10/785,265

Office Action Summary	Application No.	Applicant(s)	
	10/785,265	BURI ET AL.	
	Examiner	Art Unit	
	Evan H. Langdon	3654

DETAILED ACTION

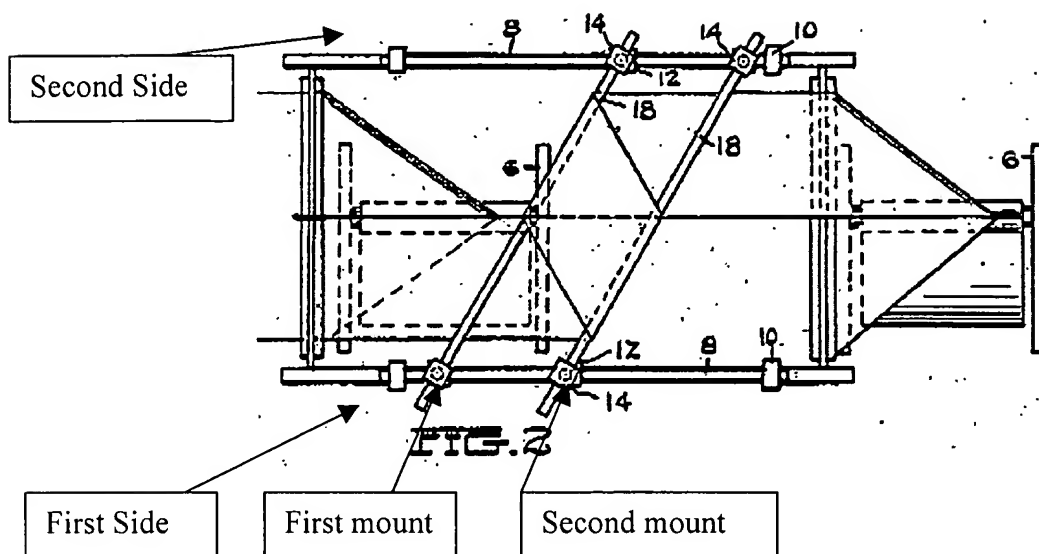
In regards to claims 19-22, Hamlin discloses the turning bars 18 can be removed from the mounts 12 while the mounts are adjusted along the guide 8, the reconnected. Hamlin discloses two mounts 12 on a first side and two mounts on a second side (Fig. 2), but fails to disclose the first turning bar attached to the second mount.

It would have been obvious to one of ordinary skill in the art at the time the invention was made to insert the first turning bar of Hamlin in the second mount on the same respective side to provide more arrangements of the turning bars (see below).
